Access Compliance Report

Public Rights-of-Way

(Curb Ramps)

Intersection ID: 12605	Main Street: KENSINGTON_DR	Cross Street: THE_PLAZA	Location: SW
ADA ID: 8329D82B7D97	Ramp Type: Directional1	Initial Pass/Fail: Fail	Overall Compliance: No
Severity Score: 1.25			
Codes/Mitigation Info/Possible Solution		Field Measurements/Component Compliance

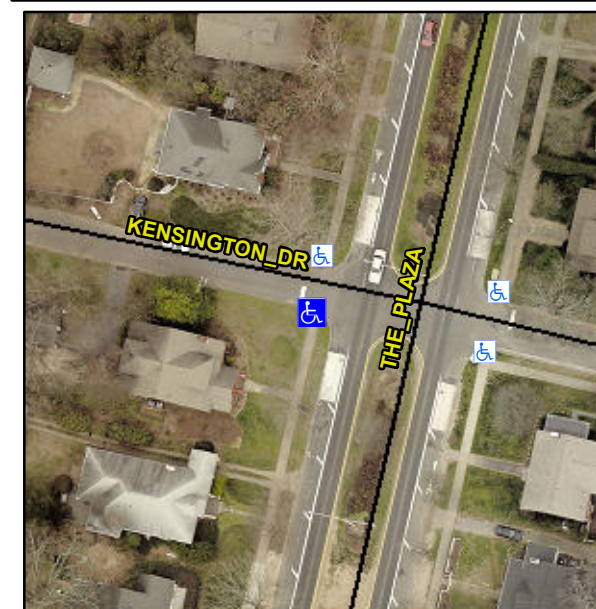
R304.5.3

Compliance	Description	Data	Compliance	Description	Data
N/A	Ramp Length (in)	99.0	N/A	Grade Break?	N/A
Yes	Ramp Width (in)	53.0	N/A	Grade Break Slope (%)	0.0
Yes	Ramp Slope (%)	6.5	N/A	Grade Break XSlope (%)	0.0
No	Ramp XSlope (%)	2.1			
N/A	Flare Type LT	N/A	N/A	Flare Type RT	N/A
N/A	Flare Slope LT (%)	N/A	N/A	Flare Slope RT (%)	0.0
N/A	Flare Traversable LT?	N/A	N/A	Flare Traversable RT?	N/A
N/A	Landing Length (in)	0.0	N/A	DWS Provided?	N/A
N/A	Landing Width (in)	0.0	N/A	DWS Contrast?	N/A
N/A	Landing Slope (%)	0.0	N/A	DWS Length (in)	N/A
N/A	Landing X Slope (%)	0.0	N/A	DWS Full Width?	N/A
N/A	Landing Curb? (Y/N)	N/A	N/A	DWS Offset LT (in)	N/A
N/A	Shared Landing?	N/A	N/A	DWS Offset RT (in)	N/A
N/A	Gutter Ponding?	Yes	N/A	Gutter Slope (%)	N/A
N/A	Gutter Lip Ht (in)	0.0	N/A	Gutter X Slope (%)	N/A
N/A	Painted X Walk1?	No		Road Slope (%)	2.2
	X Walk 1 Direction	To N		Road X Slope (%)	2.7
	X Walk 1 Width (in)	N/A		Clear Space?	N/A

Remove & Replace Entire Ramp.
